This is the **Final Office Action** for application number 10/609,174 Holding

Device for Thermoplastic Lids, filed on 6/27/03. Claims 1-41 are pending. Claims 19

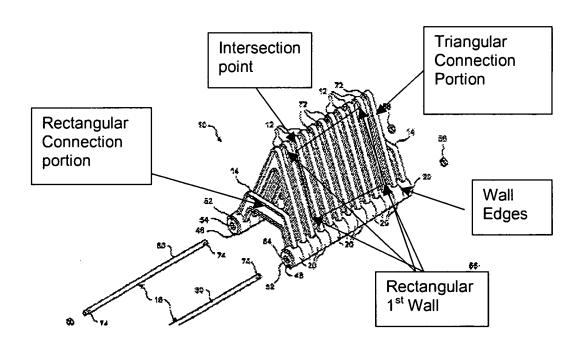
Claims 1-18, 20-27 are rejected under 35 U.S.C. 102(b) as being anticipated by United States Patent No. 6170675 to Follman et al.

The patent to Follman et al. discloses a plastic (See Col. 3, line 8-11 for material selection) holding device (10) with a first planar wall (24) which has a polygonal or rectangular shape including a first polygonal step-shaped cutout portion (72) (the cutouts are step shaped in that each one is like spaced apart like steps) providing a passage therethrough, and a step portion (70) extending from the front sides of the walls for holding object thereon and a second planar wall (28) with a second cutout portion (72) providing a passage therethrough, intersecting the first wall at an angle less than 180 degrees or 90 degrees, a first and second polygonal or rectangular or triangular connection portion (See Drawing Below for explanation), extending perpendicularly from and connecting the first and second edge portions of the first and second walls through the angle and a ridge (16) extending perpendicular from the rear side the walls.

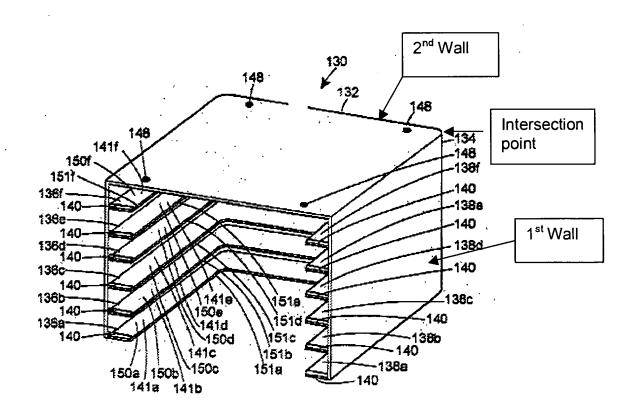
Follman et al. does not teach wherein a polygonal or rectangle or circular shaped thermoplastic lid is disposed between the cutout portions of the walls and held therein on the step portions and where the holding device includes a connecting portion extending perpendicularly from and connecting the first and second walls through a 90 degree angle.

Turvey et al. teaches a holding device for stacking thermoplastic container lids including a first and second intersecting planar walls (See Fig. Below, 134, See Fig. 18) wherein each of the walls has a step shaped or polygonal cutout portion (138a-138f) (Step shaped refers to the platforms of the cutouts which represent steps (140), and at least one thermoplastic lid (142, See Fig. 19) which can be circular (See Fig. 4) or polygonal/rectangular (See Fig. 19) disposed between the cutout portions of the walls
